***shelter***

## 1 SAMPLE STREET

#### ADVICE SOUGHT: Provide Expert Witness report for QCAT Hearing

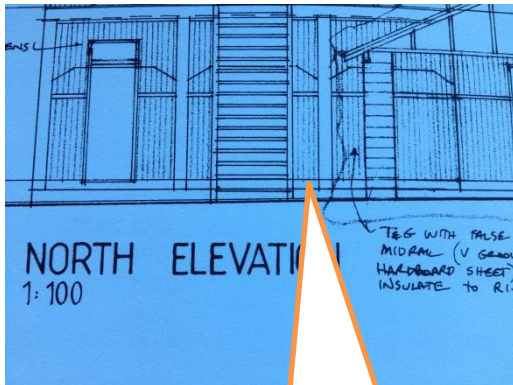
**Observation 1a:** NORTH ELEVATION on SHEET 5 of 6

- The documentation notes the base tread being generally at the same level as the Carport and as noted z\*#@ photo 1 and;
- Height difference from driveway to ground level suggesting awaiting 'finished ground levels' from graded fill.

Note 'indicative' finished height match of step to slab.

Safety issue due to height to frontage supporting proposed future fill.

**Deemed:** Incomplete works.

**Recommendation:** Owner to fill to suitable 'finished ground levels' to comply with BCA and make frontage area including fill to driveway edge foot traffic useable.

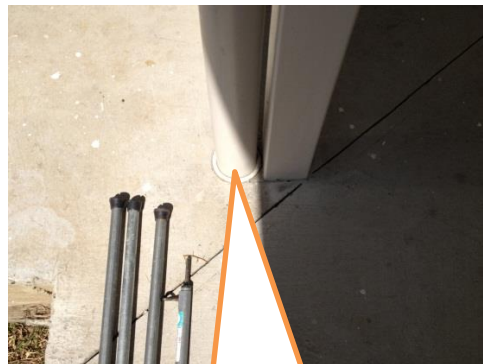
Garage is 200mm shorter in width (bracing panels also omitted). The modification has enabled the rear to mate with the house without impact. Omission of bracing panels is considered a having irrelevant structural impact with reference to AS 1170,4100,3700. The modifications to gain the extra 200mm opening to 5800mm as documented with have a substantial 'appearance' impact on the structure as it will require:

1. Structural modifications to the roof and support framing potentially disturbing the carport symmetrical- 'appearance' defect;
2. Relocating the posts will cause an appearance defect to concrete slab at base and require differing fixing methods to new post location causing 'appearance' defects;
3. Require purpose built downpipe discharge point to be relocated causing 'appearance' defects.

**Deemed:** A 'no impact non-compliance with documentation'. As it has neither an appearance or operational impact, or a not 'fit or purpose' defect, therefore it is not considered a defect.

**Recommendation:** Pursuing any 'rectification' action will be detrimental to the finished appearance of the building as the work 'as is' has no 'operational' impact to rectify. Engineering is considered not required to confirm structural adequacy for deletion of bracing walls due to method of post fixing, lateral movement roof bracing and existing house as bracing walls.

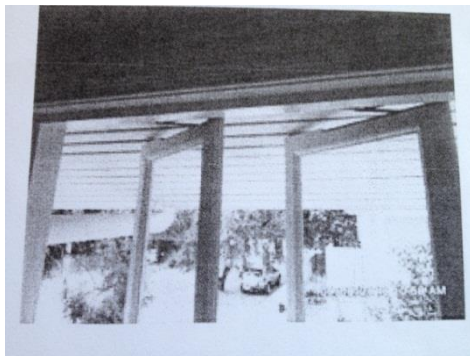
**Observation:** Wall surfaces are defective if they deviate from vertical by more than 4mm within any 2m of wall. Appears within tolerance.

**Deemed:** No defect.

**Recommendation:** No action
